APPLICATION AND  
PRELIMINARY PLAT CHECKLIST

Name of Proposed Subdivision THE SHORES PHASE TWO

PLAT REVIEW

REVISION DESCRIPTION	DATE	SCALE	DESIGN	DRAWN	<b>HAROLD L. EVANS &amp; ASSOCIATES</b> Consulting Engineers P.O. Box 28355 2331 Gus Thomasson Road, Suite 102 Dallas, Texas 75228 (214) 328-8133	<b>PRELIMINARY PLAT</b> <b>THE SHORES ~ PHASE TWO</b> CITY OF ROCKWALL, ROCKWALL COUNTY, TEXAS	SHEET NO. <b>1</b> 1
	9-18-87	1" = 100'	H.L.E. #A.	H.L.E. #A.

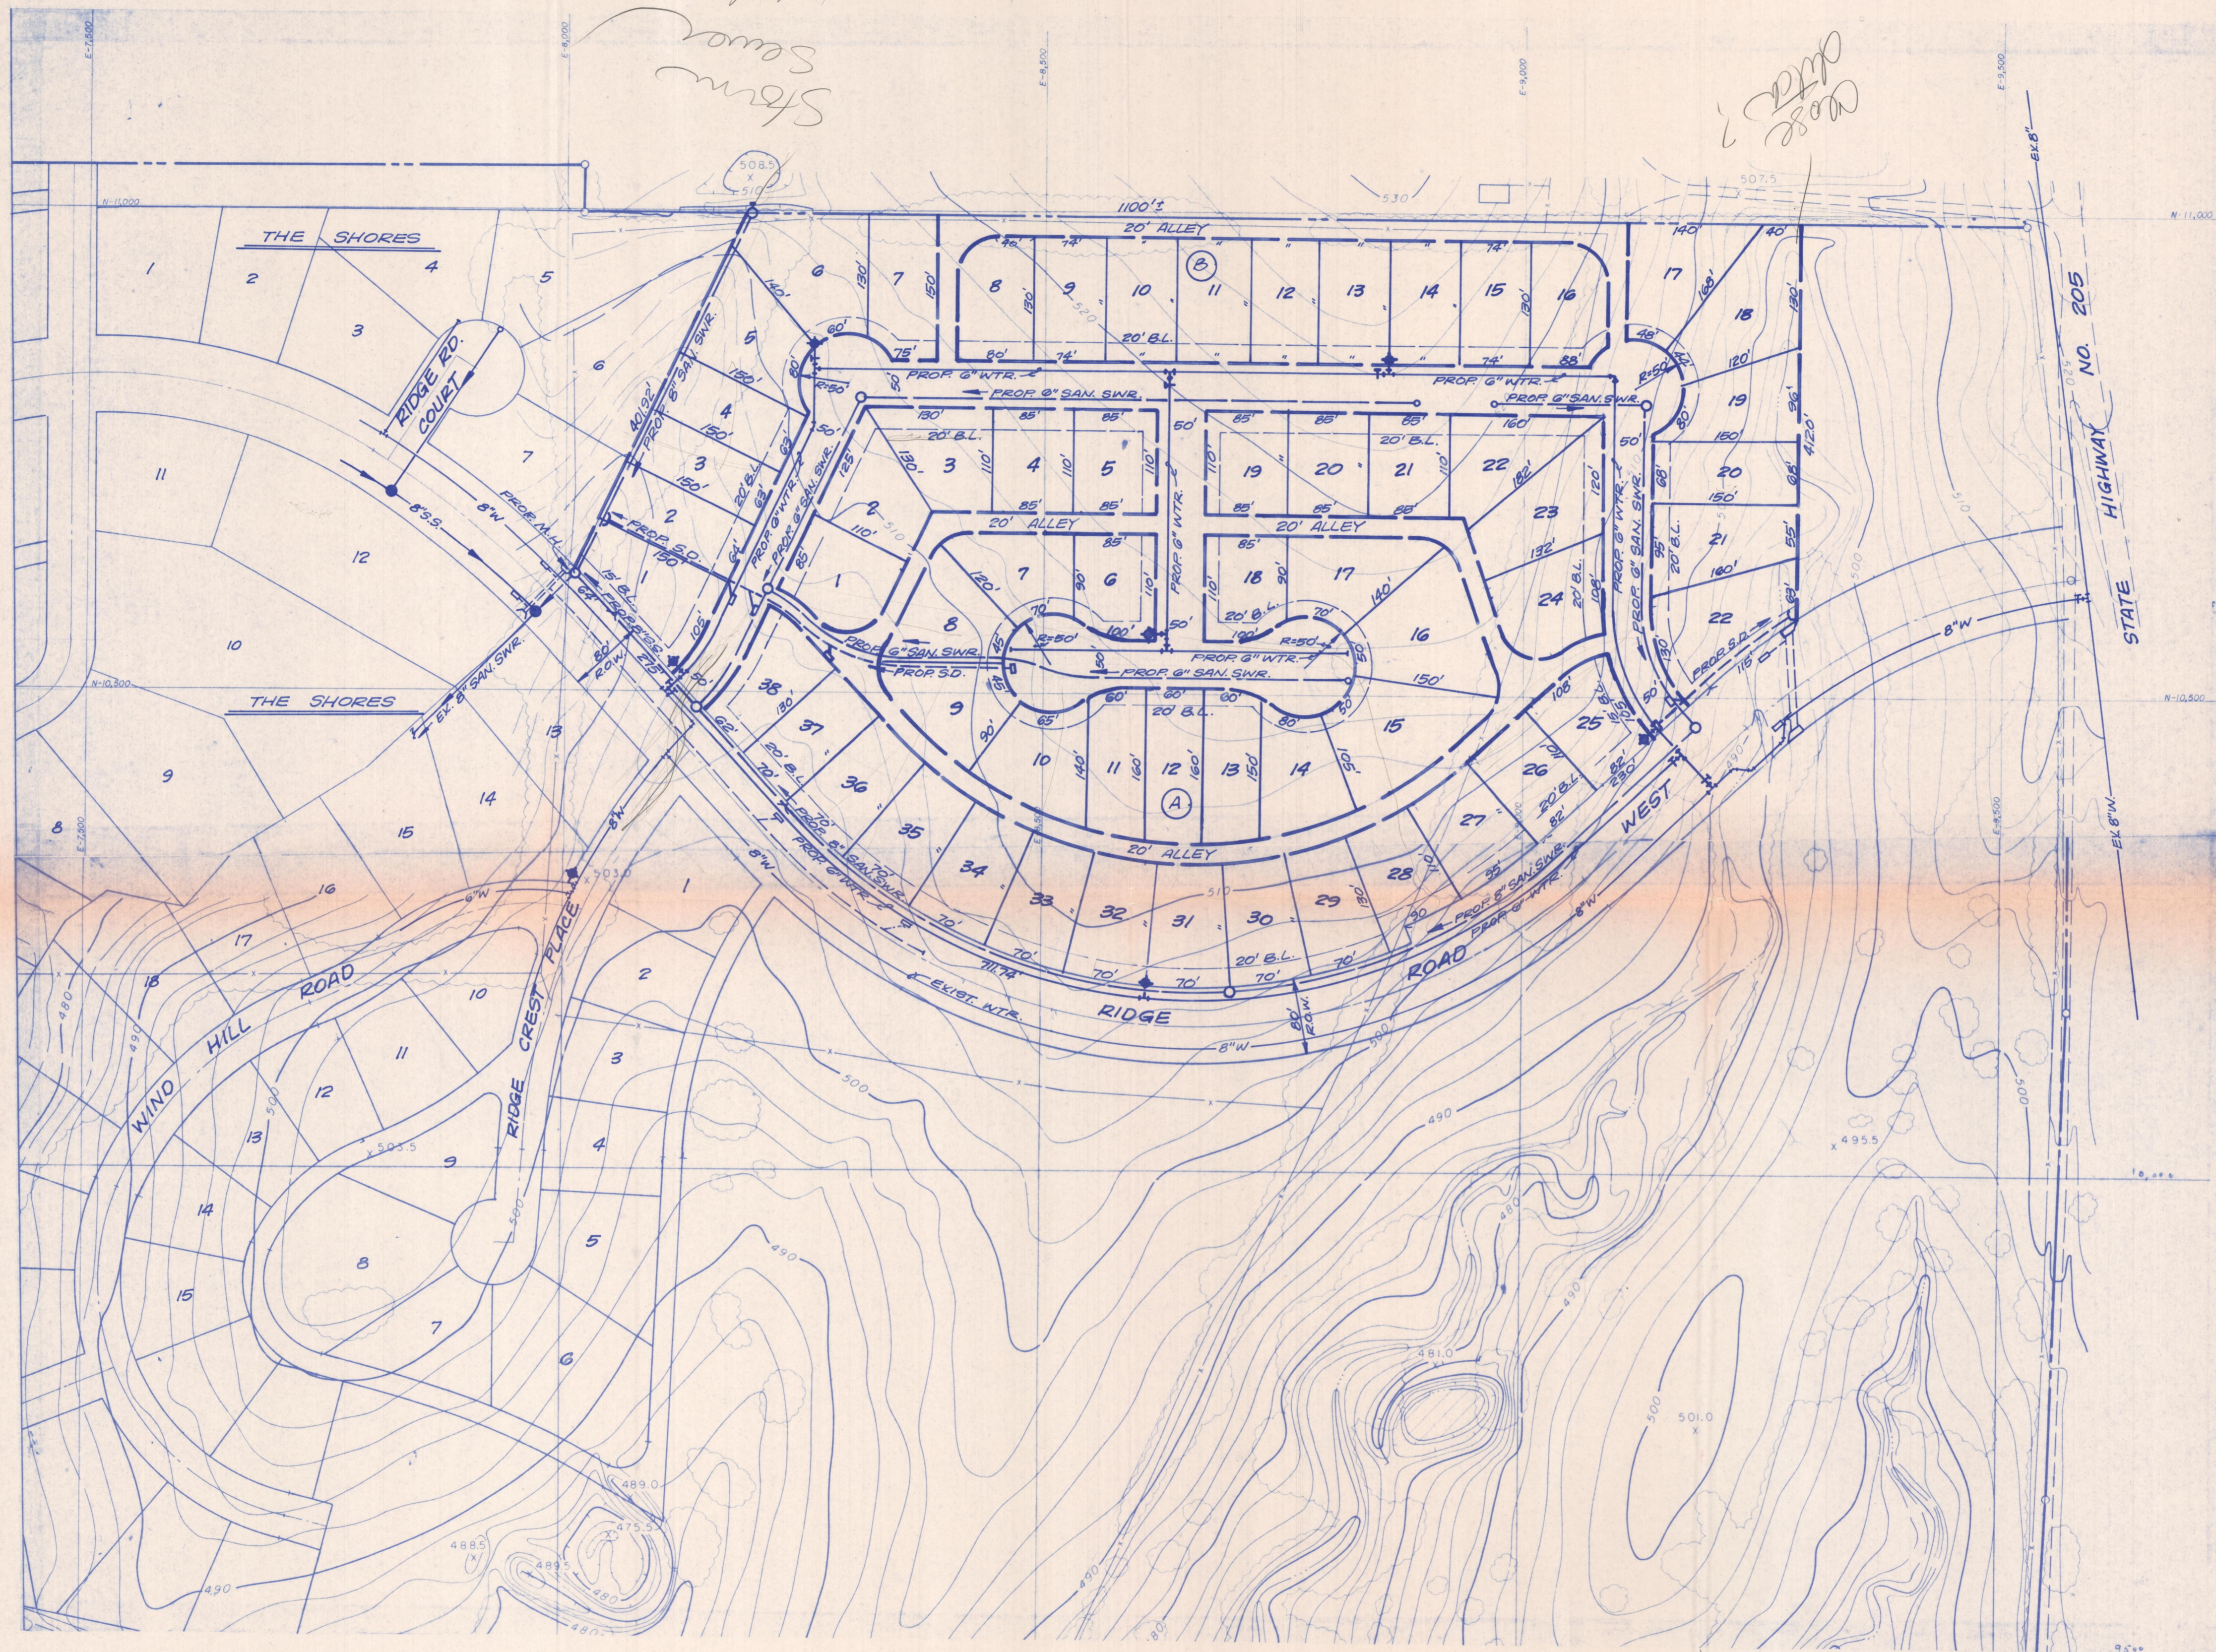
stud offset  
 street names  
 adjacent prop owners  
 crossing for traffic signal

| b. Building Line <i>needs to be 25' per PD ord.</i>  | <input type="checkbox"/>            | <input checked="" type="checkbox"/> | <input type="checkbox"/>            |

14. Comments: *there is an offset intersection on a curve that needs to be corrected*

*offset intersection* \_\_\_\_\_      ✓      \_\_\_\_\_

*Storm Sewer  
what looks like close*

The only other substantive request we have made is that the westernmost street accessing Ridge Road West be realigned to eliminate the offset intersection with Ridge Crest Place.

On October 19<sup>i</sup>, 1987, the Rockwall City Council approved a preliminary plat for The Shores, Phase II subject to revision of the alignment of Ridge Crest Place at Ridge Road West.

Phase II - Revision of alignment of Ridge Crest Place at Ridge  
Road West
